NOVEMBER 22, 2024

PROJECT NO: 624-6777

RE: PROLOGIS HUMBER STATION – TEMPORARY STORMWATER MANAGEMENT OUTLET

Check By: R.A. R.A. Drawing: **FIG 01**

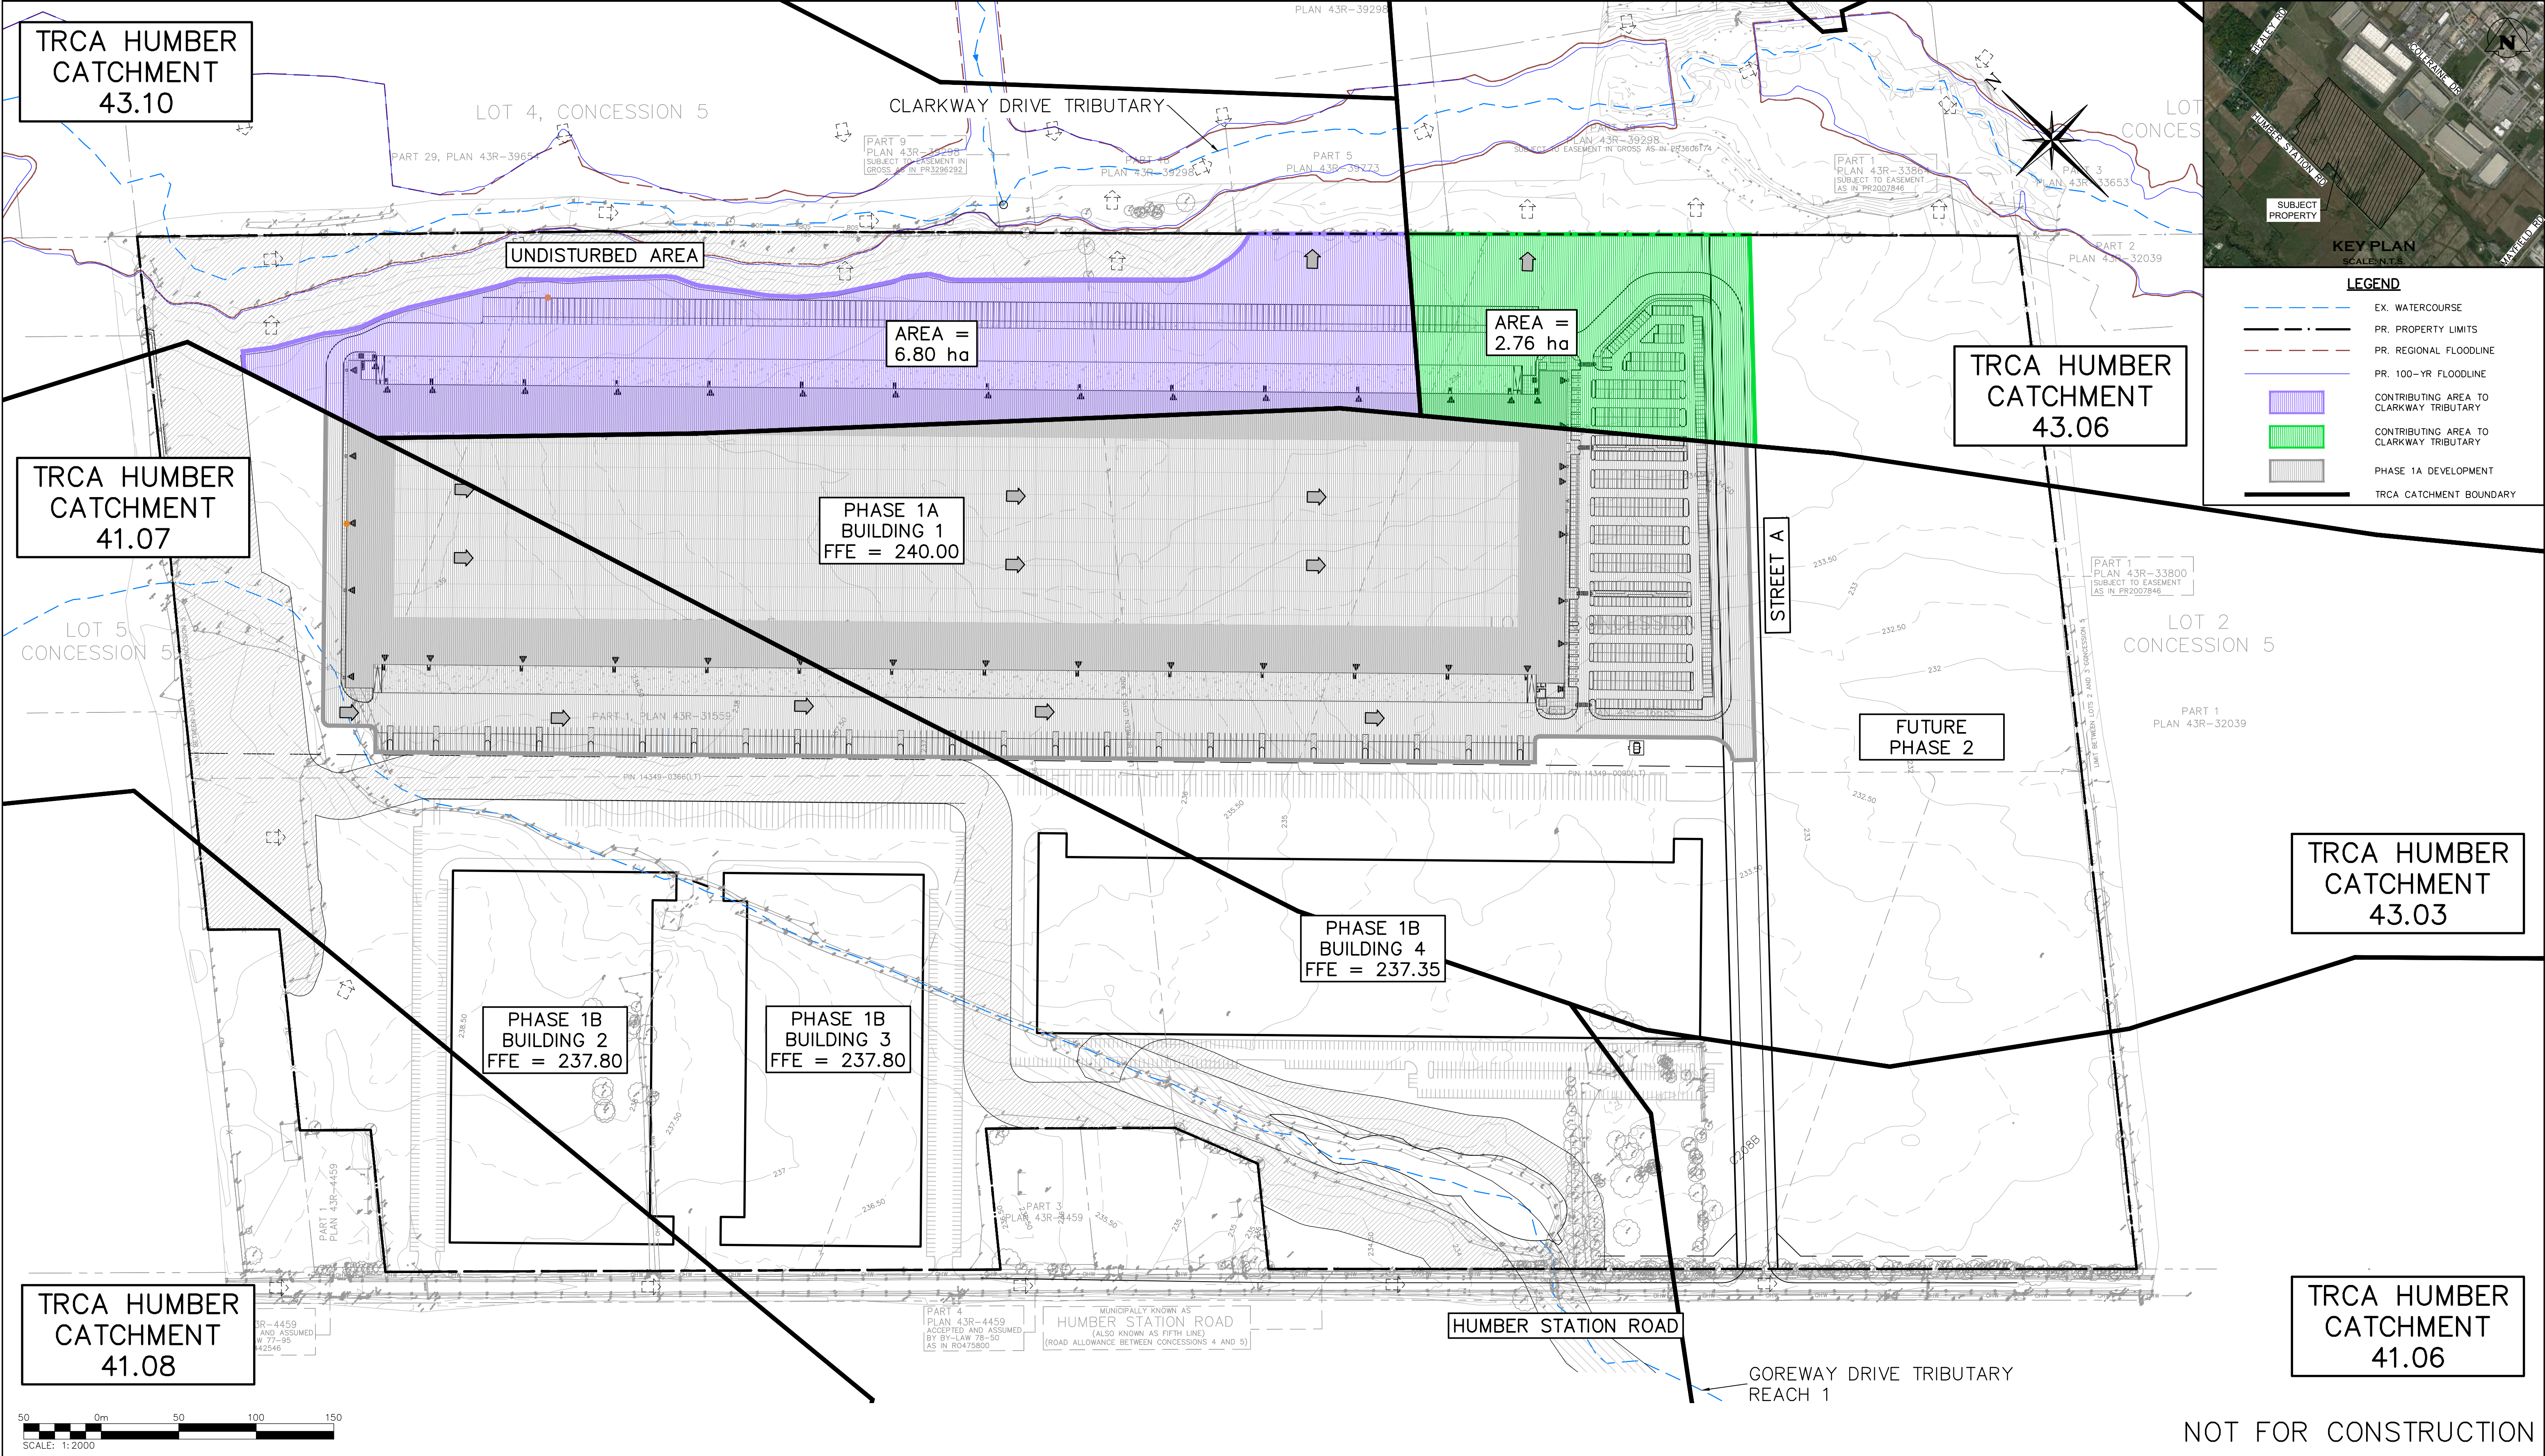
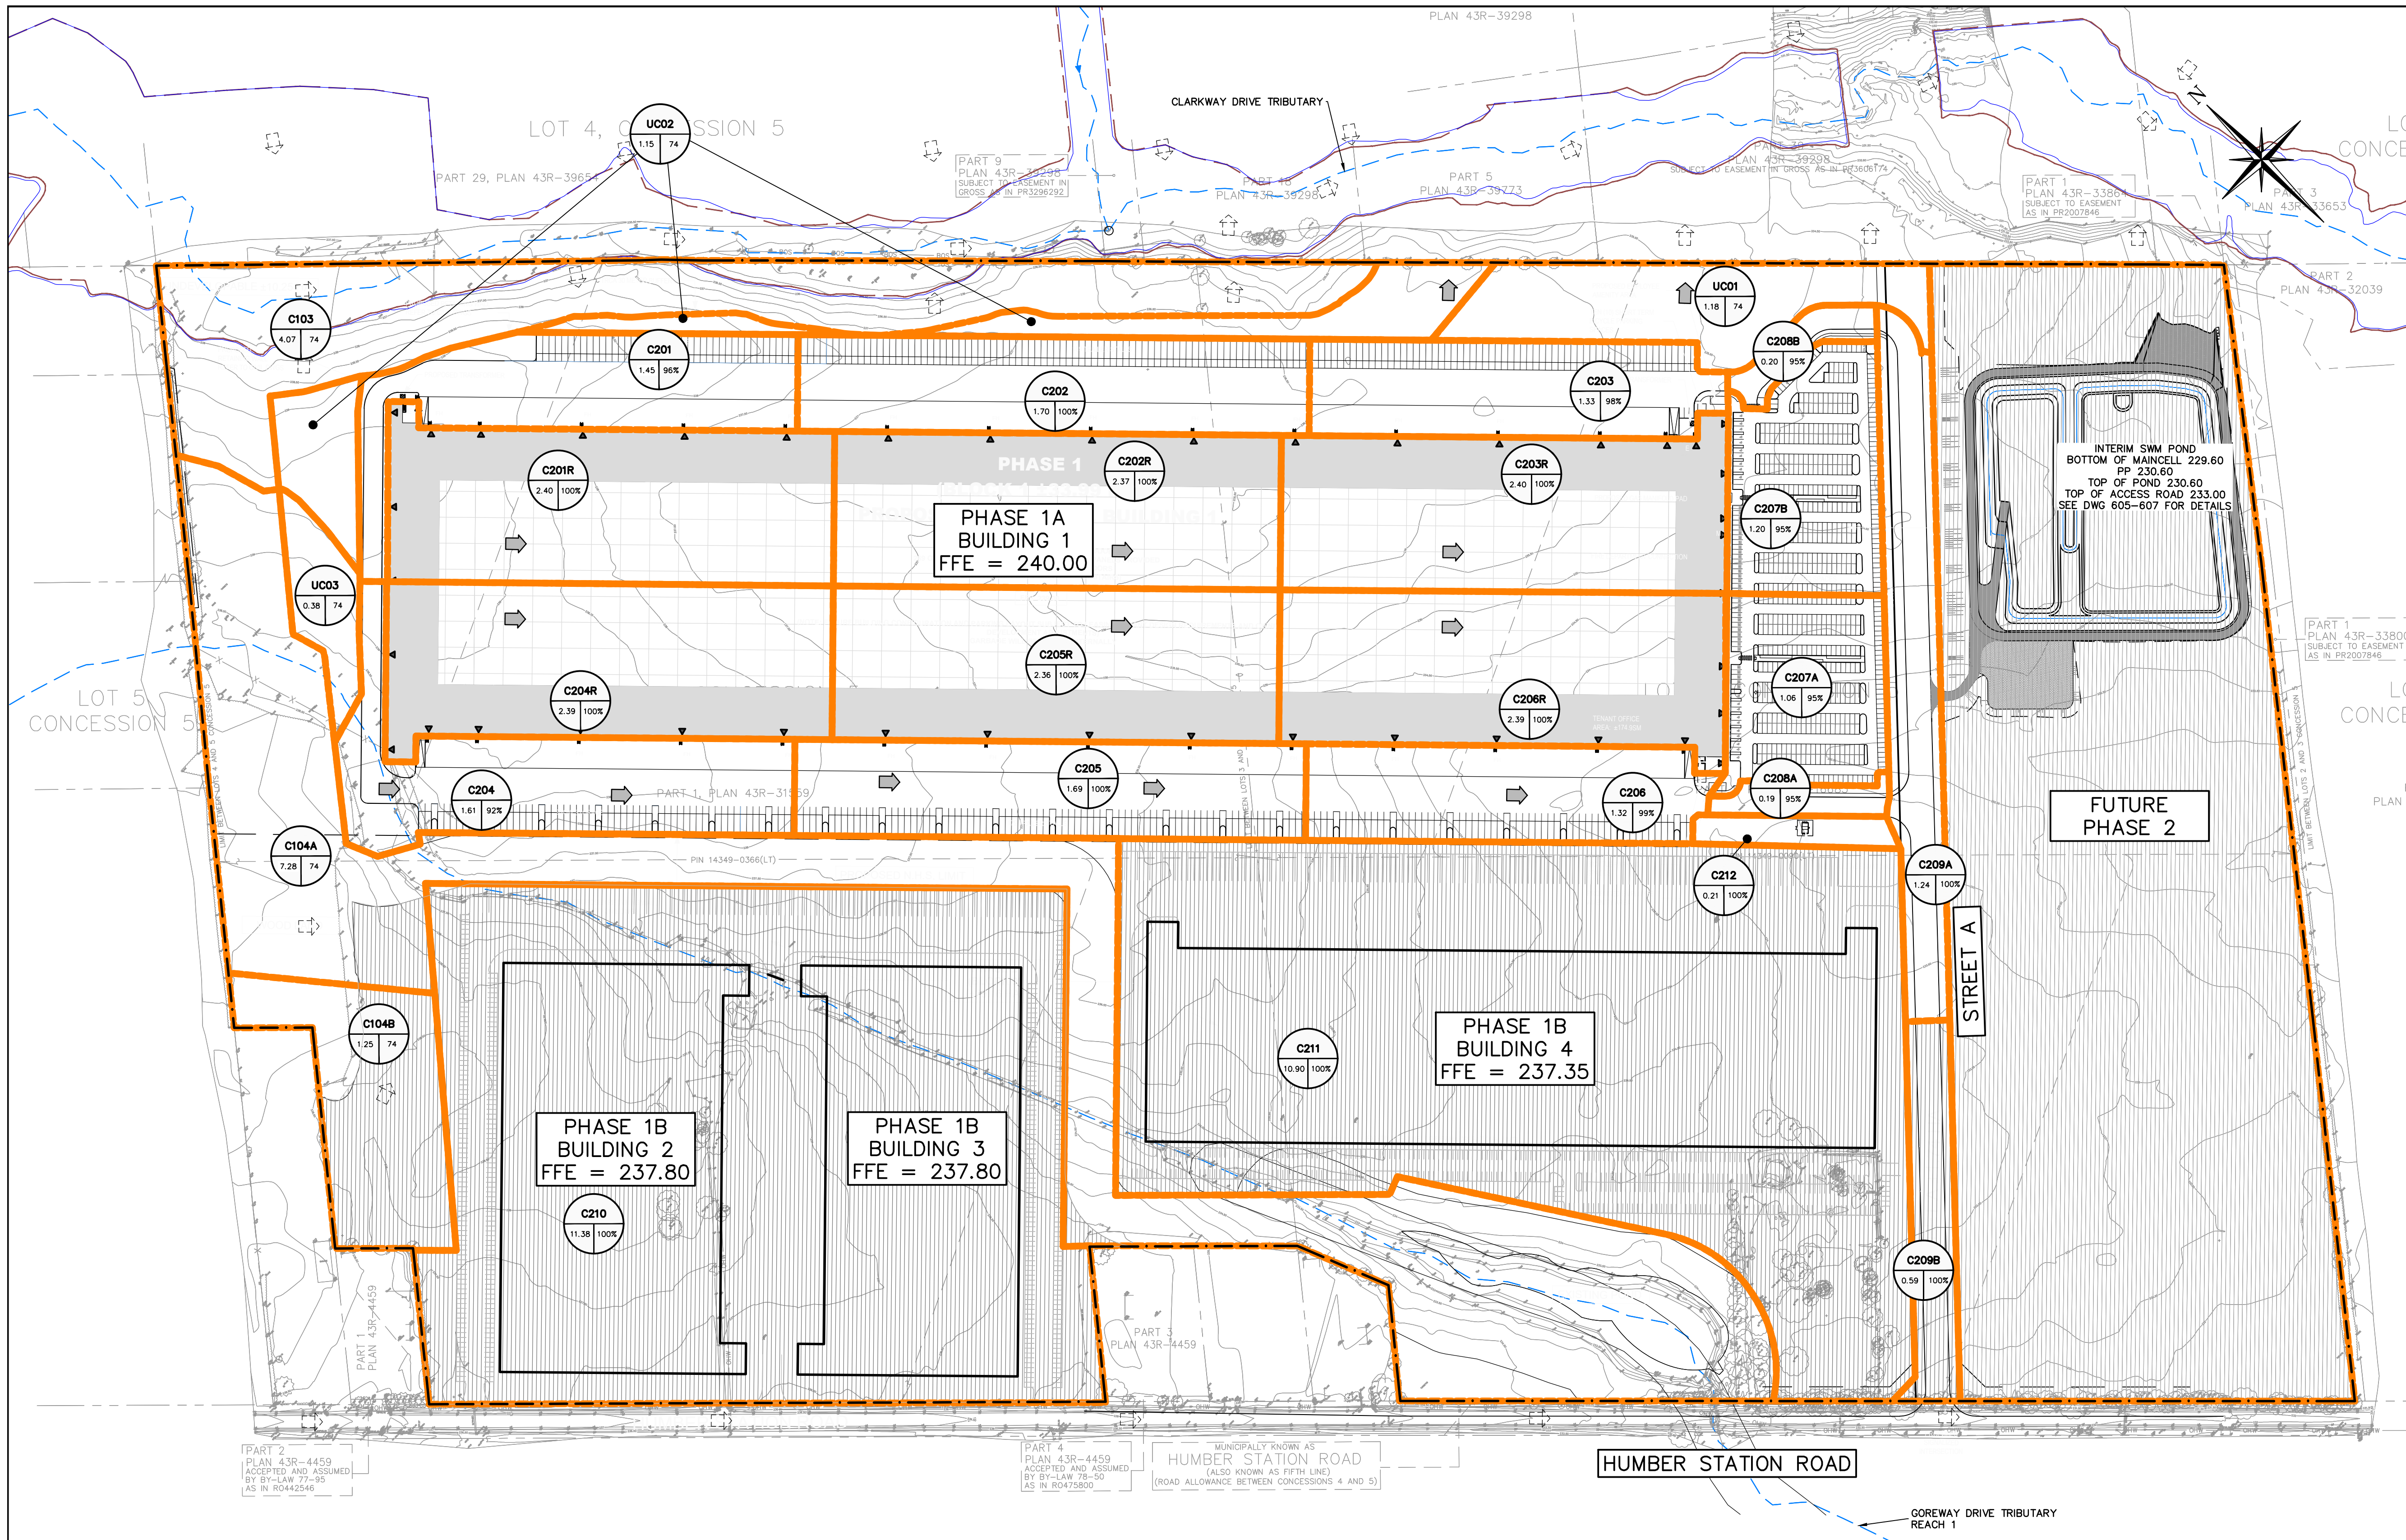
1. *The initial step is to calculate the required site release rates for the portion of the subject properties that drains to the Clarkway Tributary under existing conditions and determine the storage requirements for the stormwater management (SWM) pond accordingly using the criterion.*

The Humber River unitary flow rates for Sub-basin 36 were used to determine the allowable release rates to the Clarkway Tributary for the property. The 9.56 ha area along the northeast property line that drains to the Clarkway Tributary in existing conditions was used for this calculation. The TRCA Humber catchments were used to delineate this area as shown in **Figure 1**.

Check By: R.A. Check By: R.A. Drawing: FIG 02

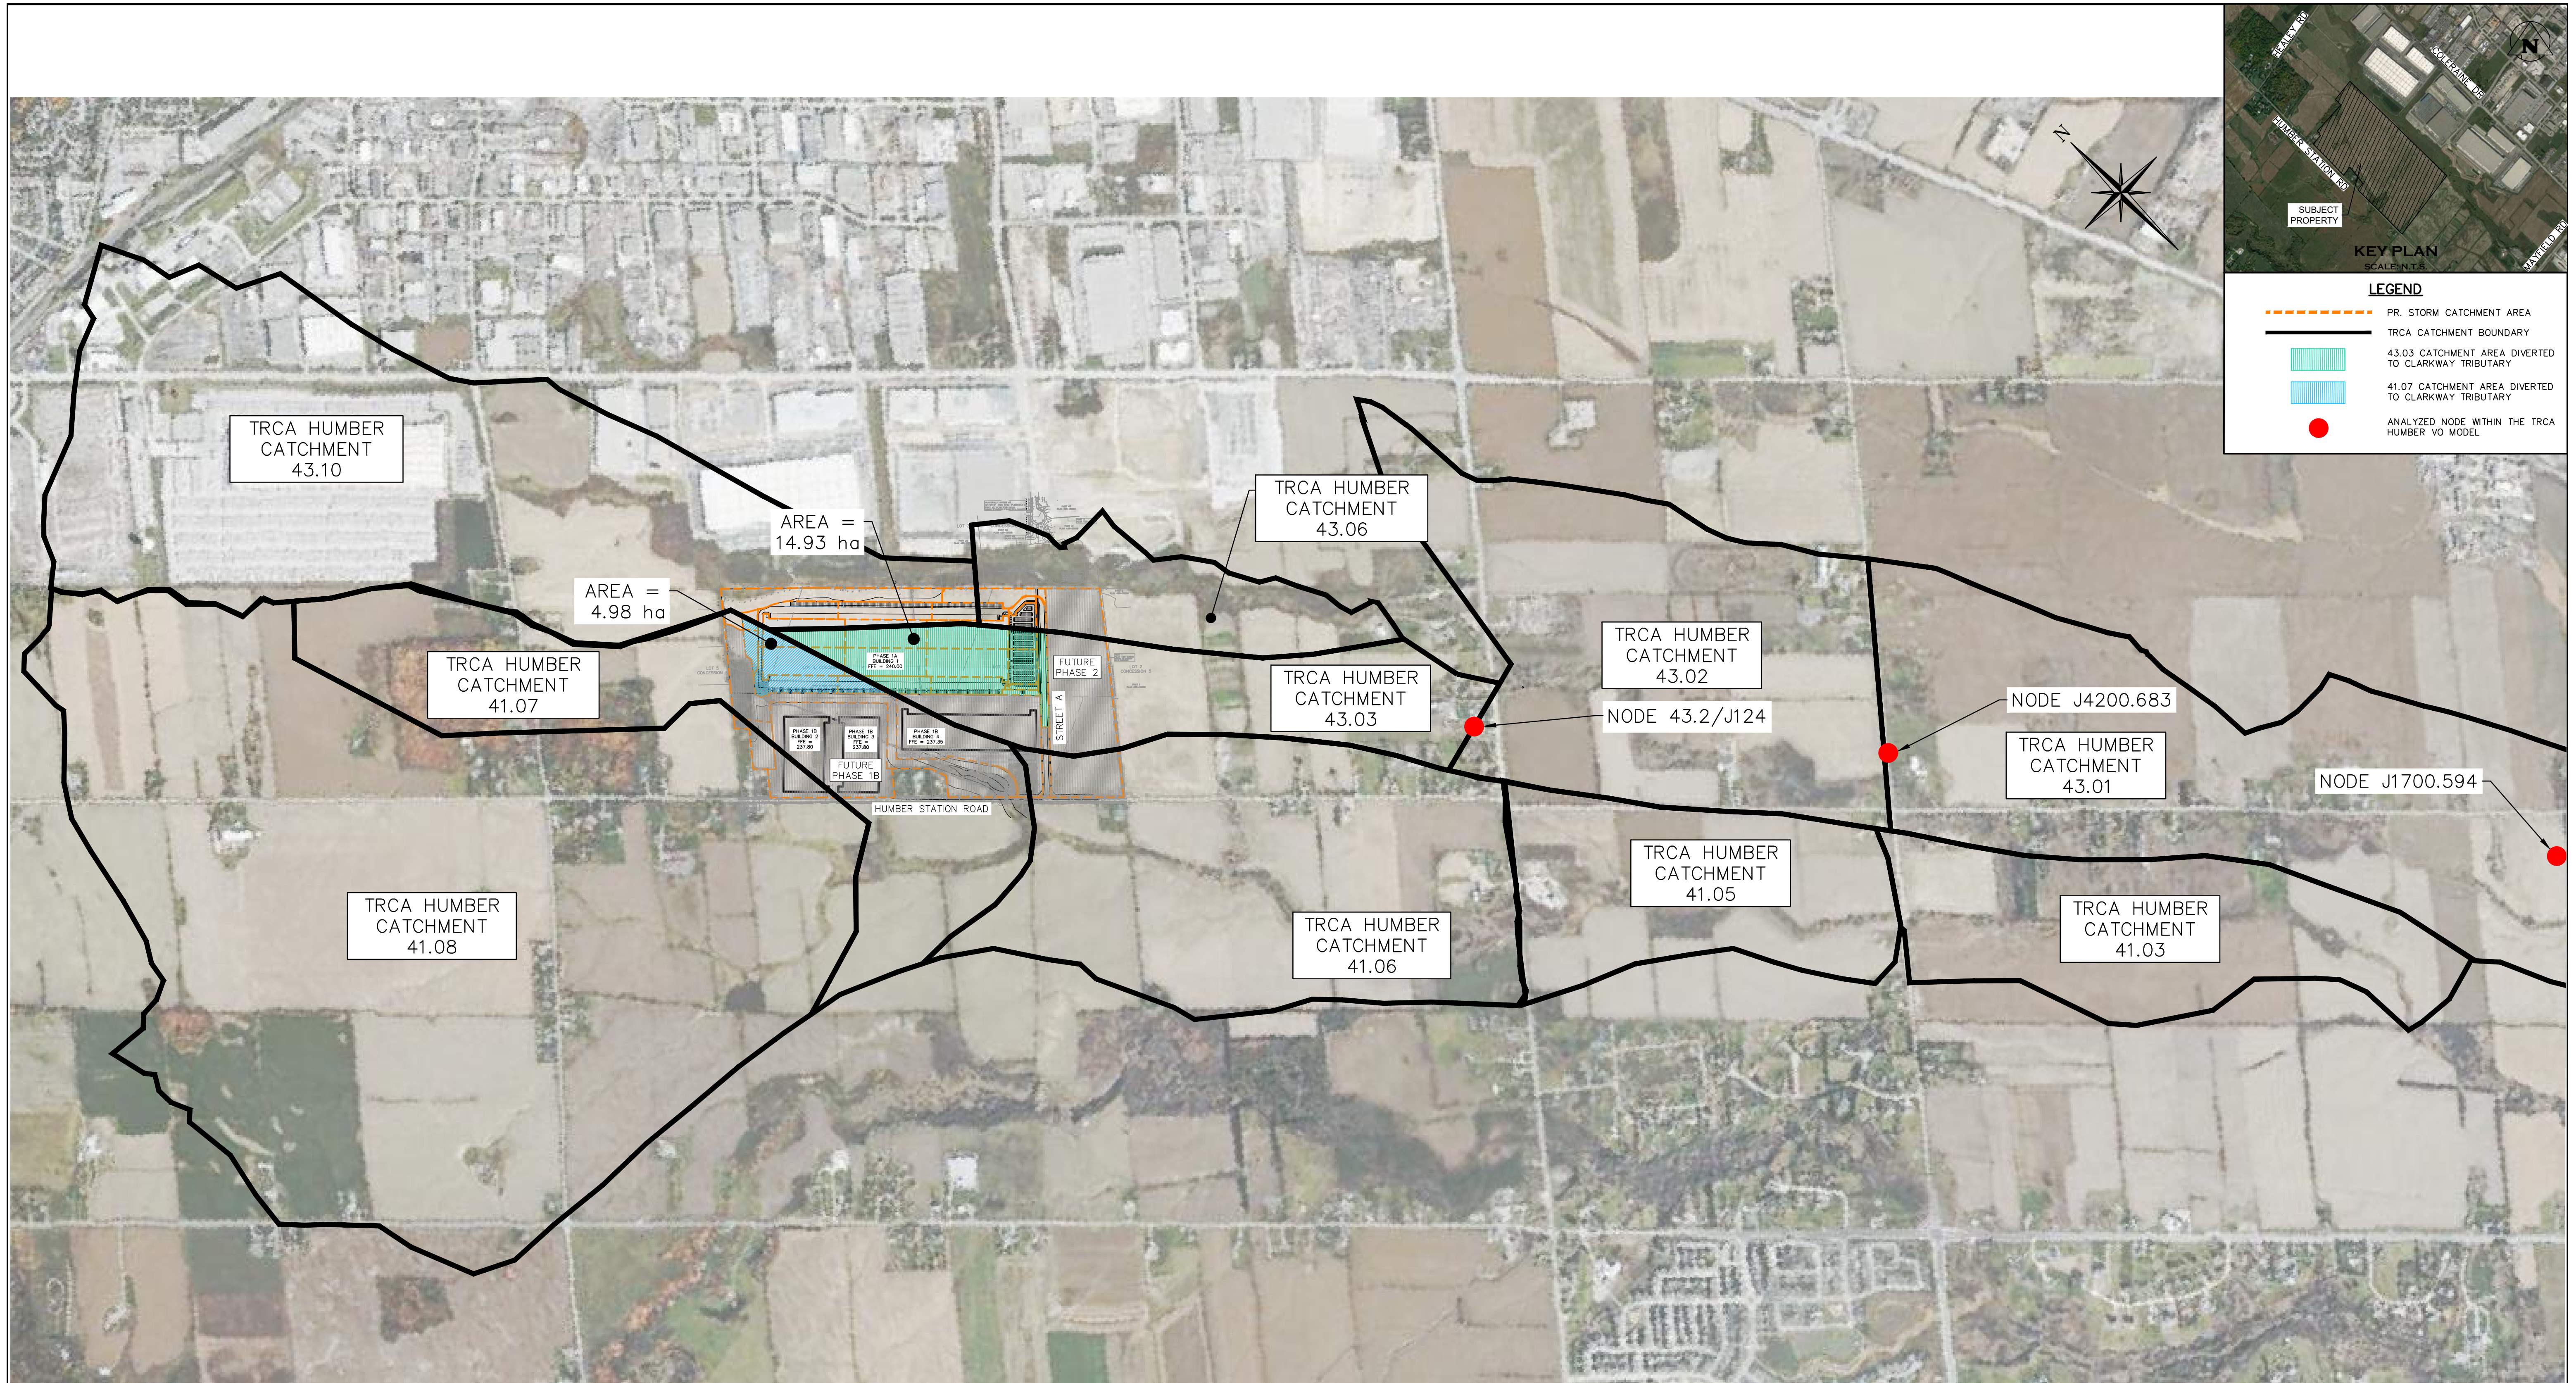
3. *Identify contributing drainage area to the proposed interim outlet location in Clarkway Tributary and summarize in a drainage map.*
 - a. *Compare the upstream area and diversion area.*

Figure 2 attached shows the post-development catchment areas from Phase 1A that are to drain to the interim outlet location. It also shows the proposed SWM facility. **Figure 3** shows the upstream area contributing to the tributary and highlights the areas within Phase 1A that are proposed to be diverted. The diverted areas are summarized in the table below. As shown, the 13.93 ha diverted area is very minor in comparison to the total 651.6 ha contributing area, representing 2.14% of the total area.
